17 PARK STREET WENDOUREE

2021052TP

RE COUNCIL RFI ISSUE
SHADOW DIAGRAMS

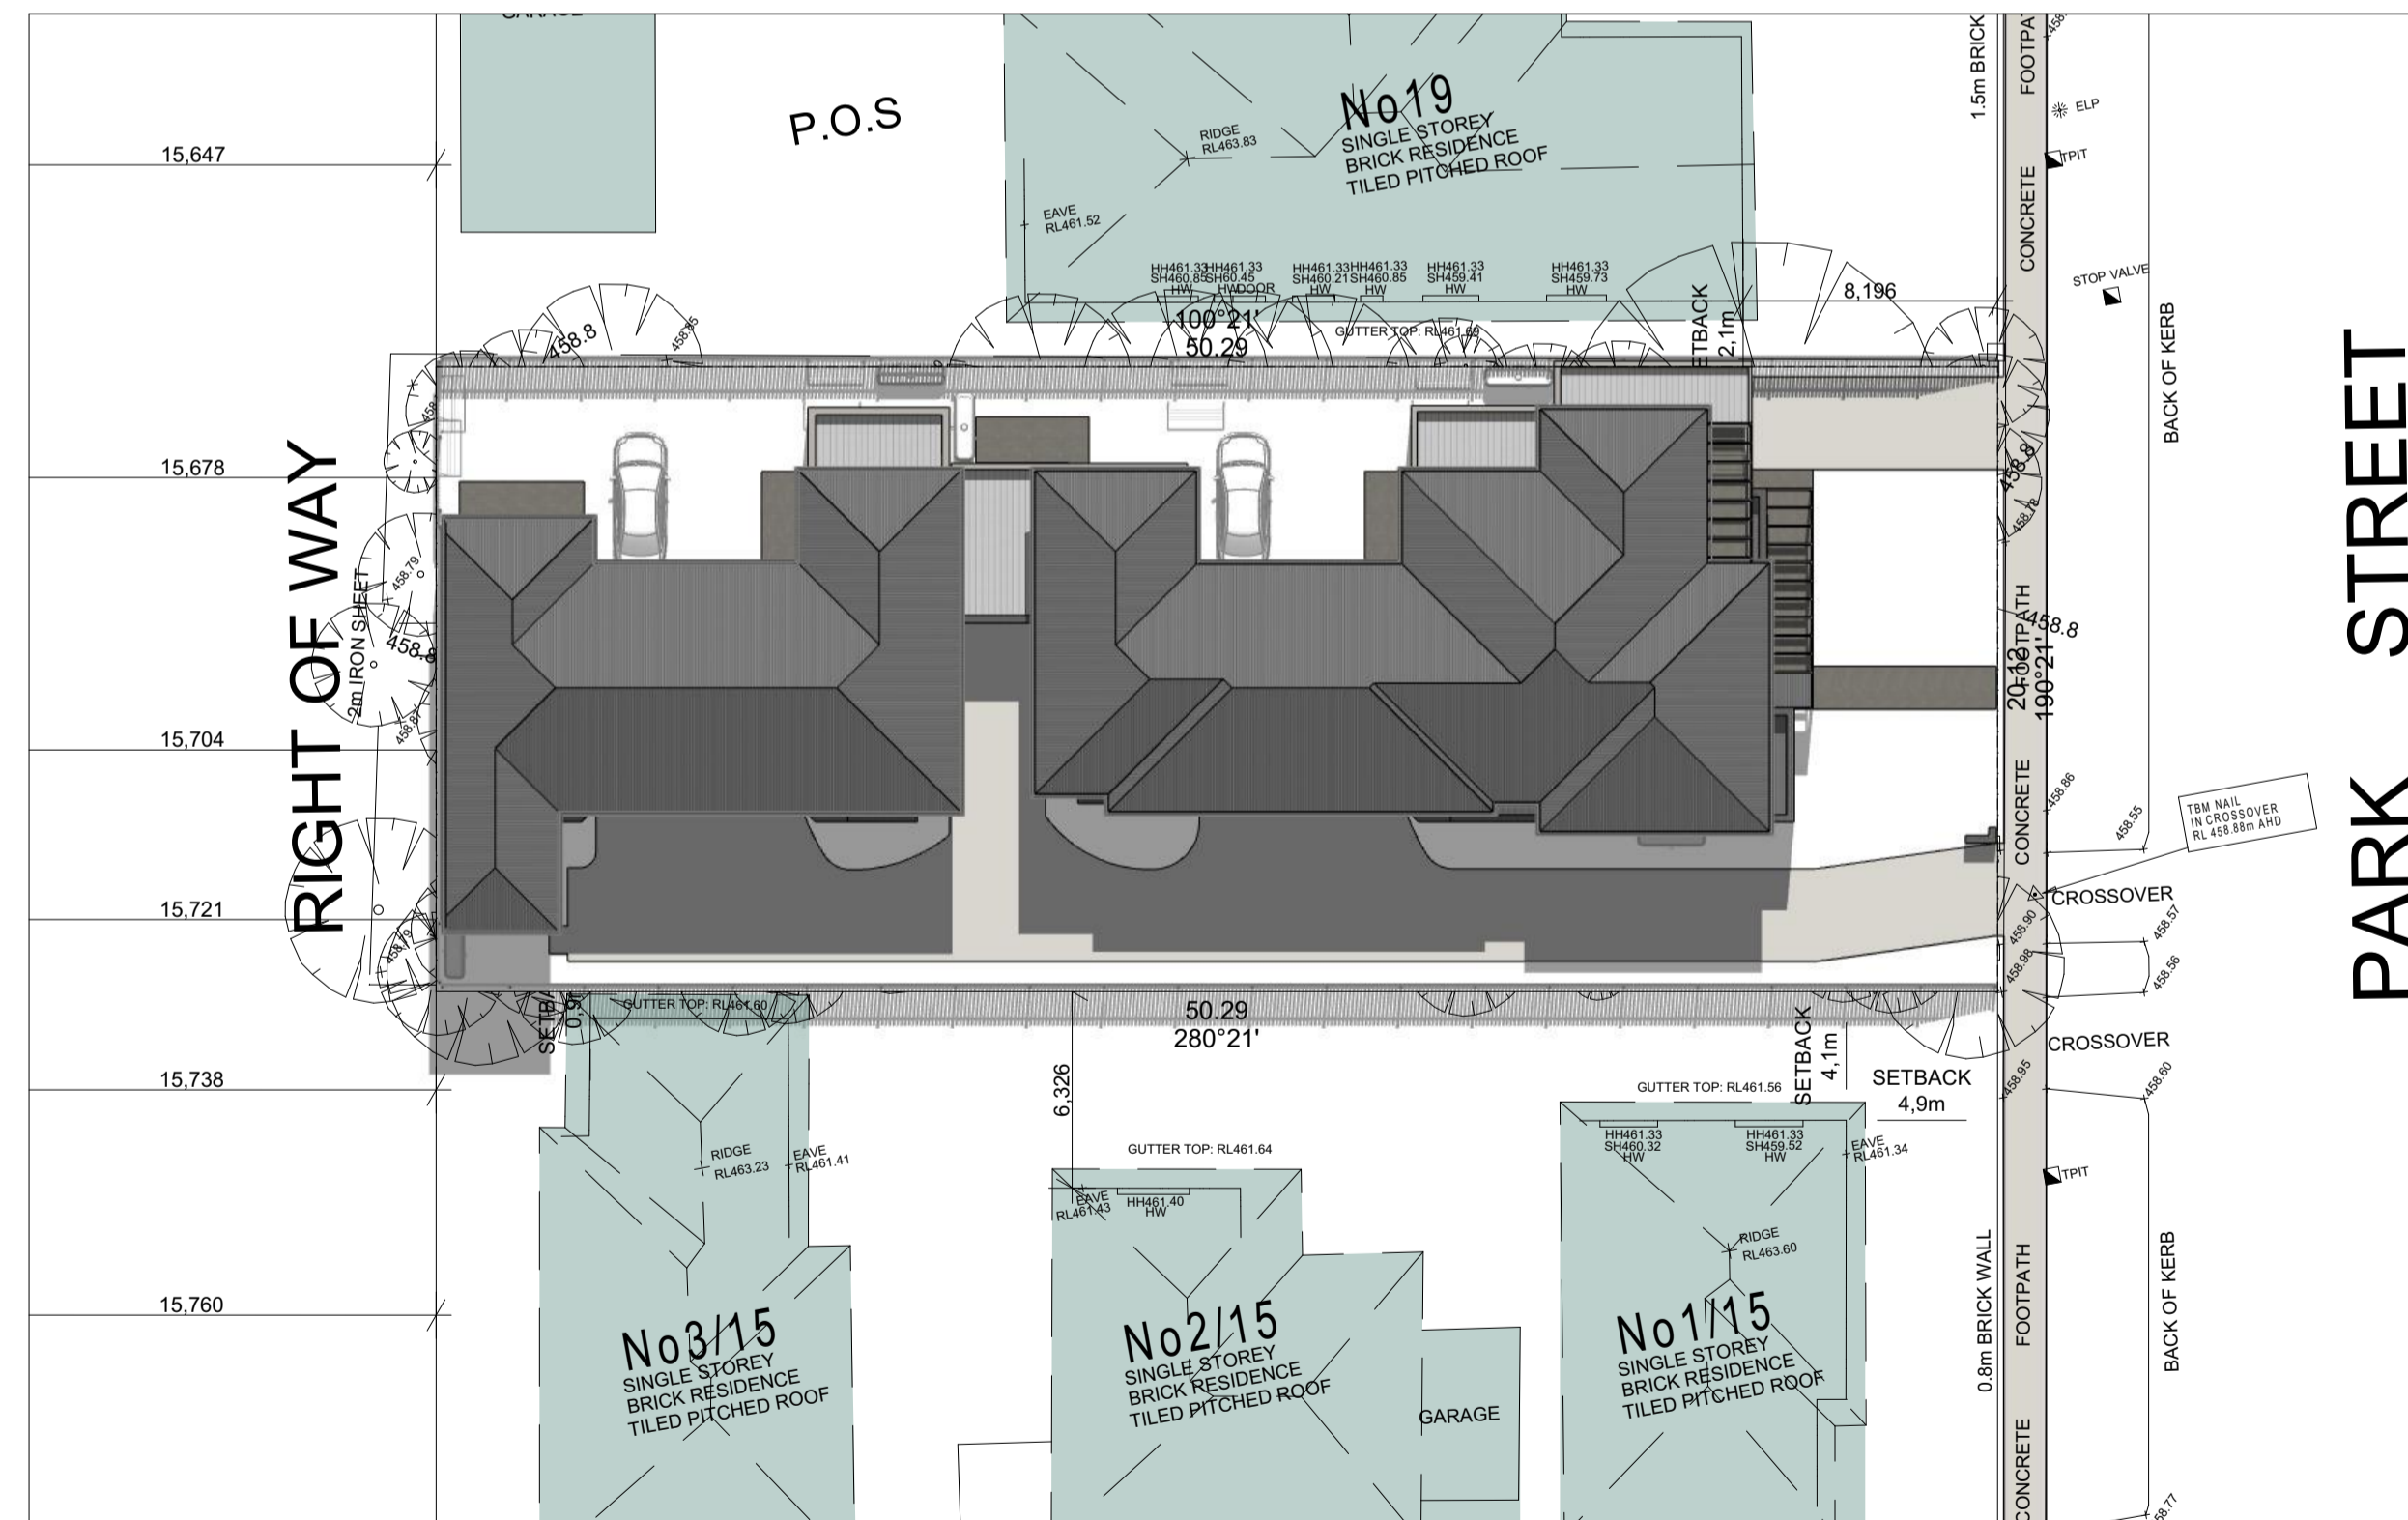
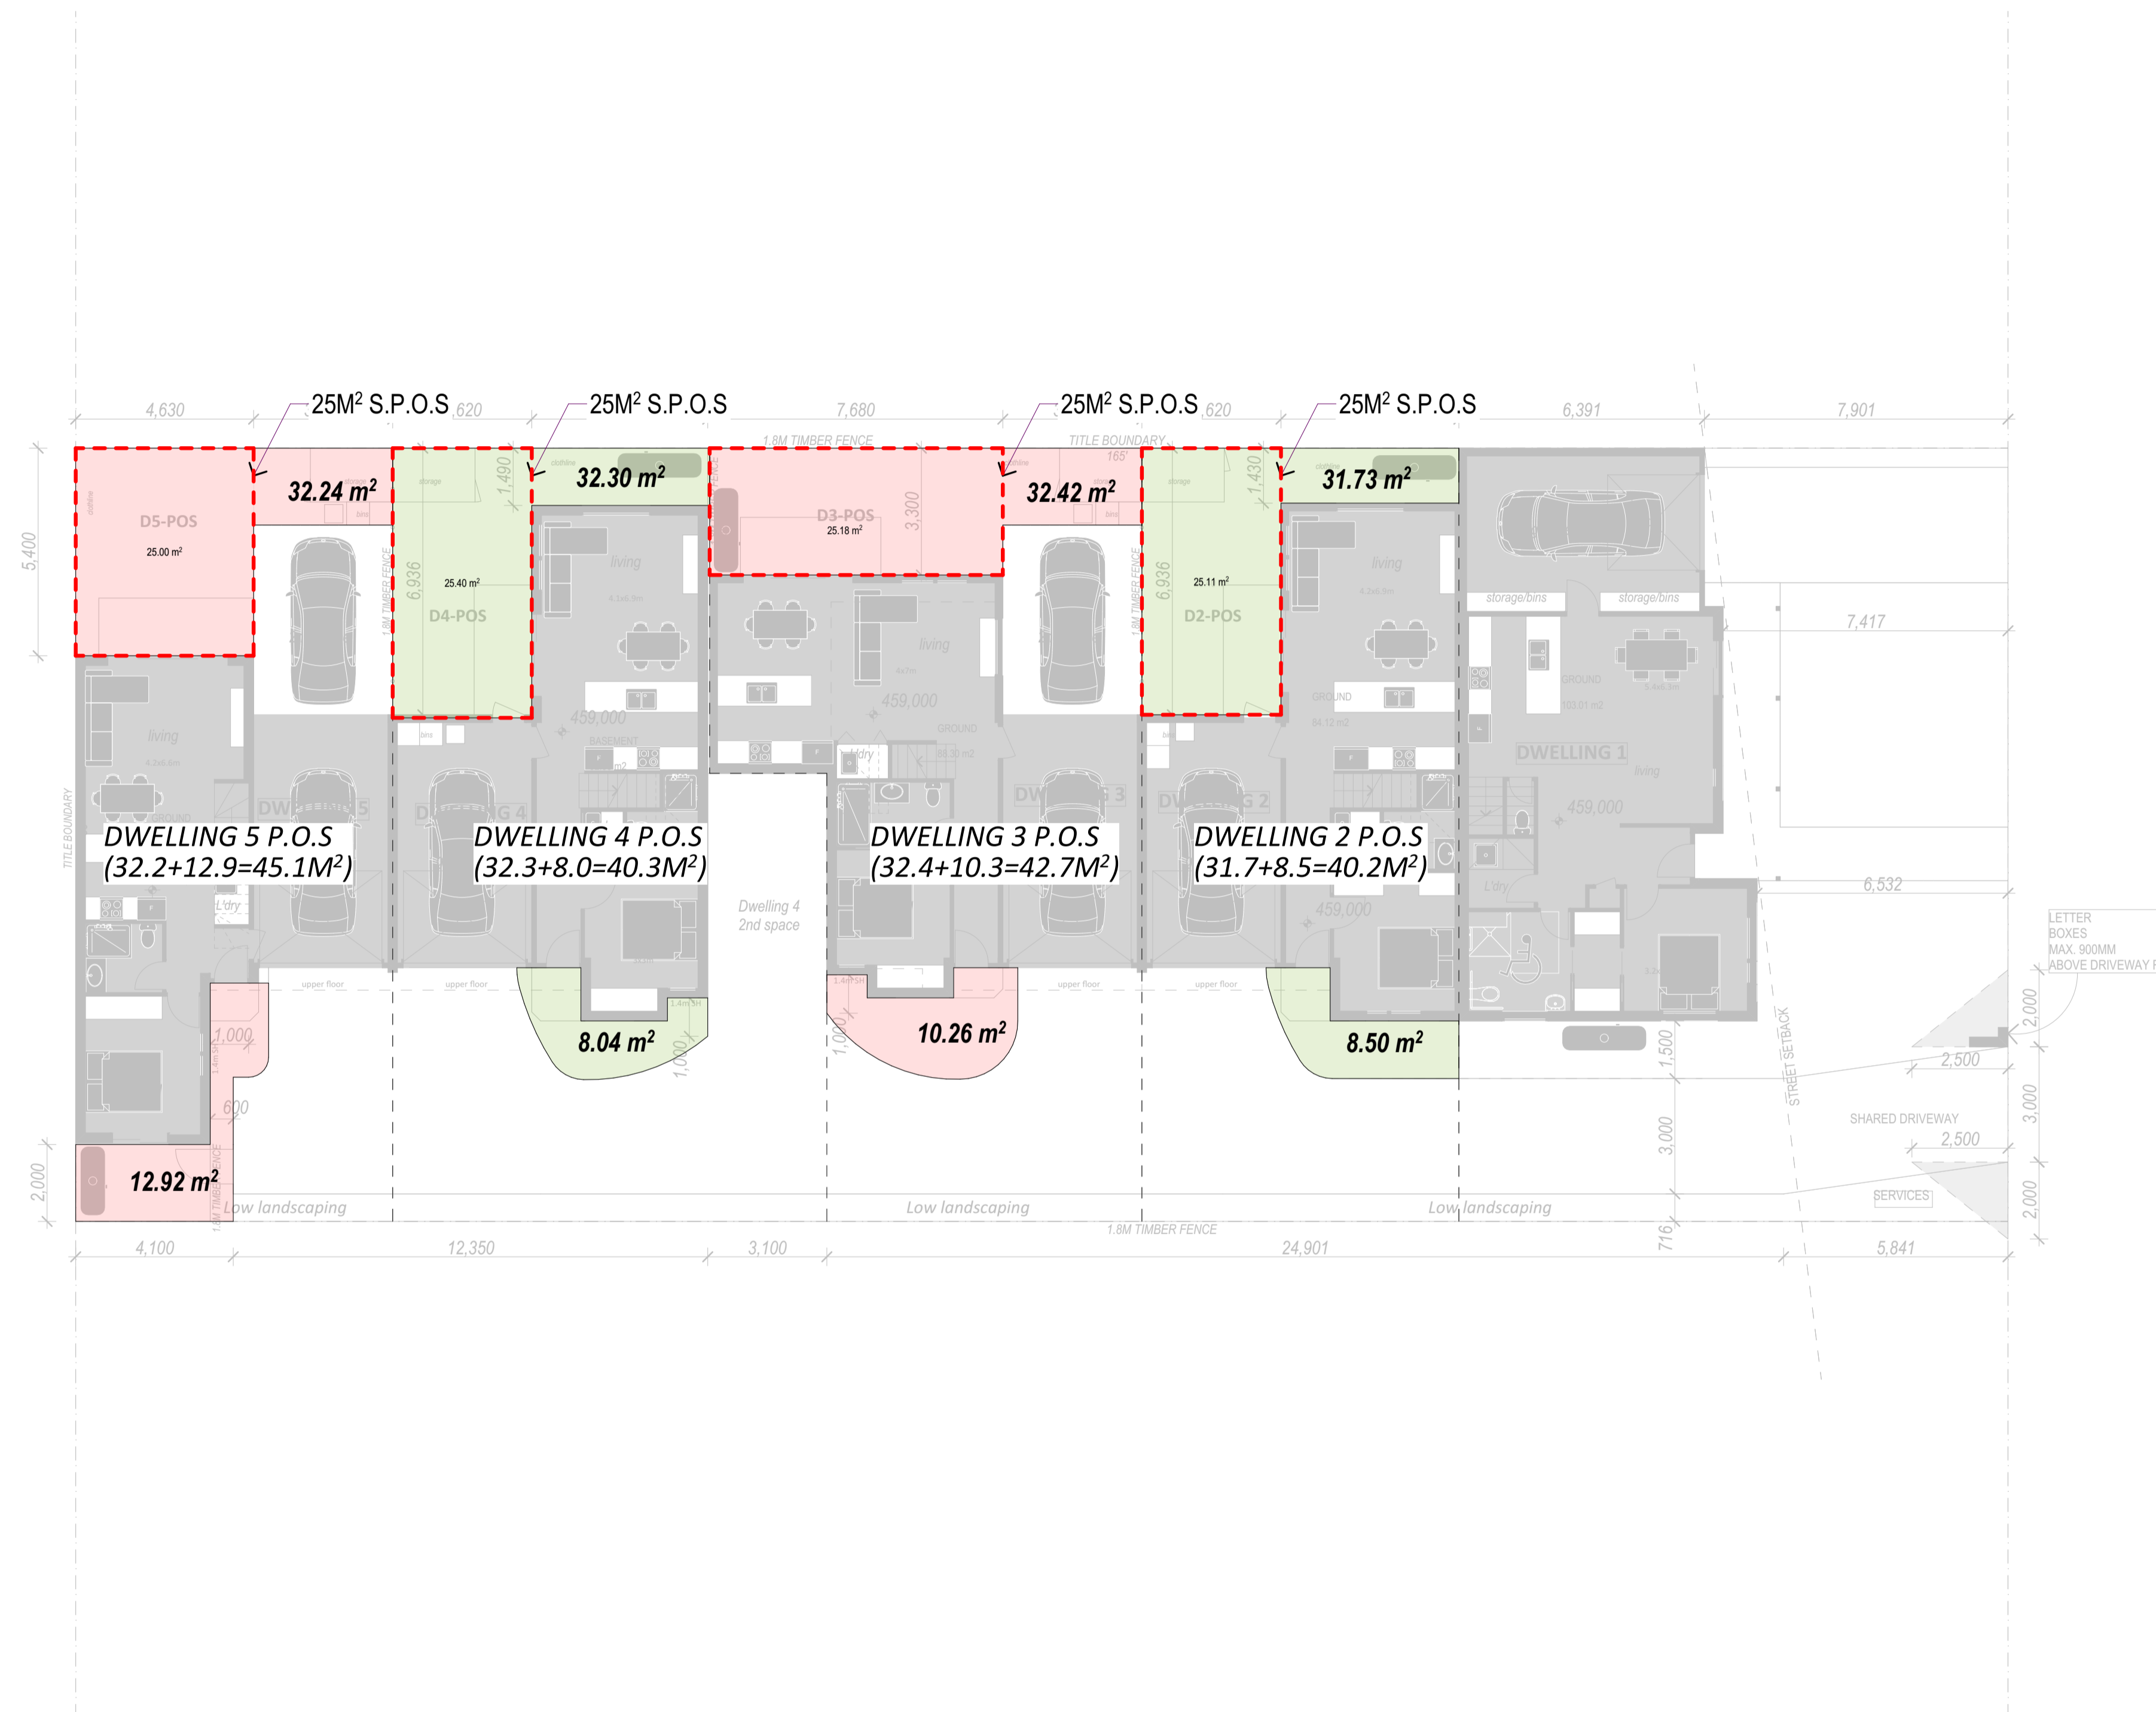
<p>55.04-3 Daylight to existing windows objective</p>	<p>Standard B19</p>	<p>Met</p>	<p>Comments</p>
<p><i>To allow adequate daylight into existing habitable room windows</i></p>	<p><i>Buildings opposite an existing habitable room window should provide for a light court to the existing window that has a minimum area of 3sqm and minimum dimensions of 1m clear to the sky. The calculation of the area may include land on the abutting lot</i></p> <p><i>Walls or carports more than 3m in height opposite an existing habitable room window should be set back from the window at least 50% of the height of the new wall if the wall is within a 55° arc from the centre of the existing window. The arc may be swung to within 35° of the plane of the wall containing the existing window</i></p> <p><i>Where the existing window is above ground floor level, the wall height is measured from the floor level of the room containing the window</i></p> <p><i>Refer to Diagram B2</i></p>	<p>Obj Met</p>	<p>The proposal will meet the objective of 55.04-3, ensuring neighbouring properties will retain adequate access to daylight via habitable room windows.</p> <p>Habitable windows located opposite the subject site within the dwelling at 19 Park Street are setback approximately 2m from the common boundary.</p> <p>Habitable windows located opposite the subject site in Unit 1 / 15 Park Street are setback 4m from the common boundary.</p> <p>Habitable windows located opposite the subject site in Unit 2 / 15 Park Street are setback 6m from the common boundary.</p>

RE COUNCIL RFI ISSUE
POS DIAGRAM

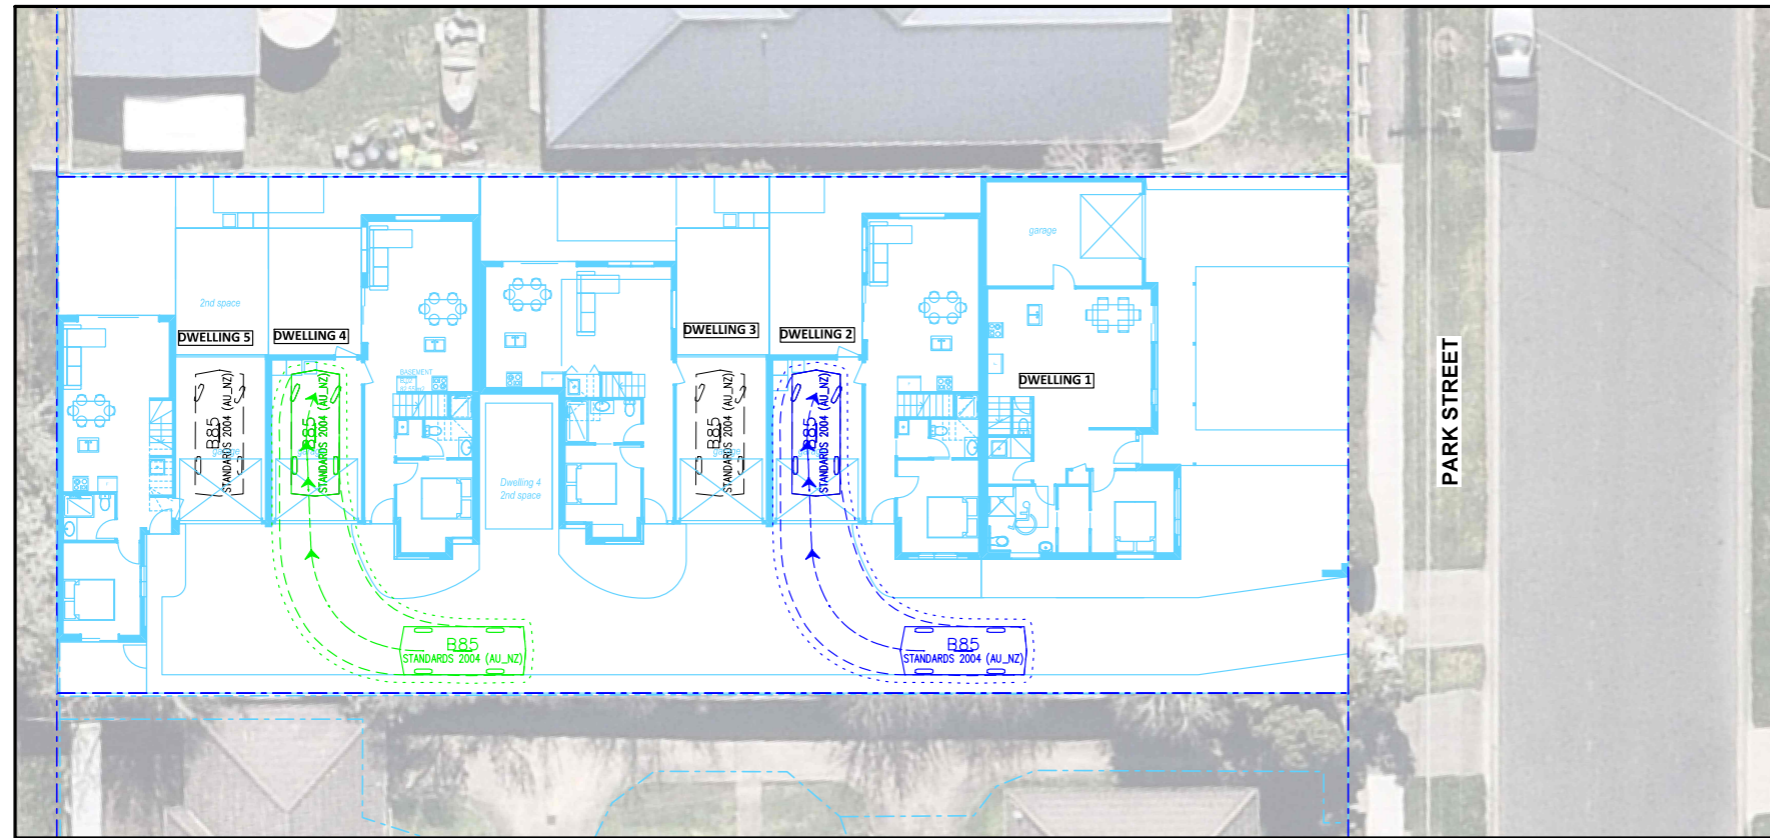
55.05-4 Private open space objective	Standard B28	Met	Comments
<i>To provide adequate private open space for the reasonable recreation and service needs of residents</i>	<p><i>A dwelling or residential building should have private open space:</i></p> <ul style="list-style-type: none"> <i>an area of 40sqm, with one part secluded at the side or rear with a min area of 25sqm, a min dimension of 3m and convenient access from a living room, or</i> <i>a balcony of 8sqm with a min width of 1.6m and convenient access from a living room, or</i> <i>a roof-top area of 10sqm with a min width of 2m and convenient access from a living room</i> 	Yes	<p>Each dwelling will be provided with direct access to private open space. The private open space provision is as follows:</p> <p>Dwelling 1 – a total of 70sqm of private open space located at the front of the property. With an additional 8.74sqm of secluded private open space provided through the first floor balcony.</p> <p>Dwelling 2 – a total of 40.2sqm of private open space, of which 24sqm will be secluded.</p>
